Response to Stakeholder Comments

Ameren Missouri – 2014 Integrated Resource Plan

Ameren Missouri 2014 IRP (EO-2015-0084)

Figure 1: Avoided Energy Cost Comparison

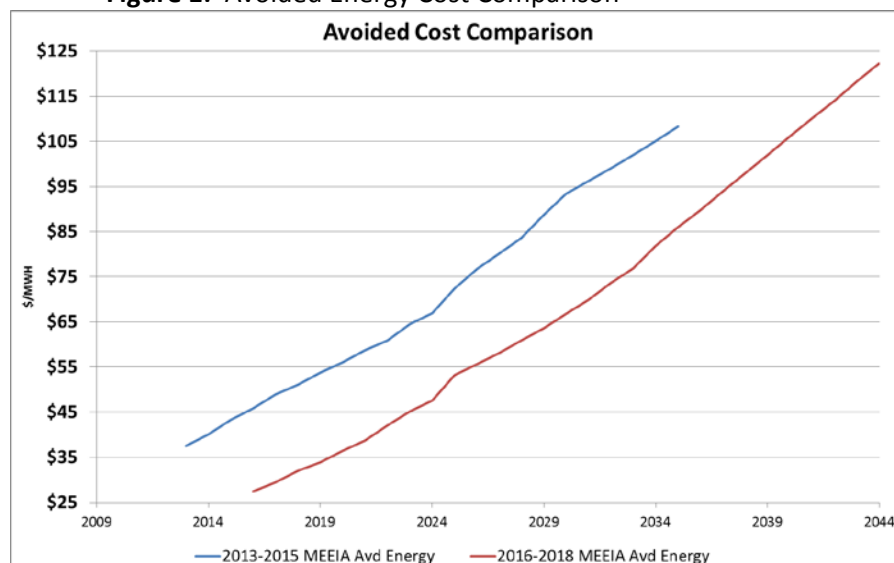
Description: Downward adjustments to program potential due to EM&V, avoided costs, and codes and standards are inappropriate.

Response: The MEEIA Testimony provides extensive explanation on why the adjustments to program potential are appropriate. These factors include:

- EISA legislation and the ensuing increase in mandated higher efficiency levels for lighting make CFLs cost ineffective for MEEIA 2016-2018
- EM&V analyses reduced the Residential Appliance Recycling load reductions for a refrigerator from 1400 kWh per unit, which was assumed in the DSM Potential study, to 1000 kWh per unit from 2013 EM&V to a projected 700 kWh per unit for MEEIA 2016-2018

- EM&V impact analyses showed that HVAC equipment savings were 80% of the levels used in the DSM Potential study.
- EM&V showed that most occupancy sensors, programmable thermostats, smart power strips, among many other measures are no longer cost effective

- EM&V showed that the interactive effects for the Residential New Homes program where such that individual measure realization rates were less than 50% and NTG < 30%

- Reduction in avoided energy costs between the Company's 2011 and 2014 IRPs can be seen in the figure below
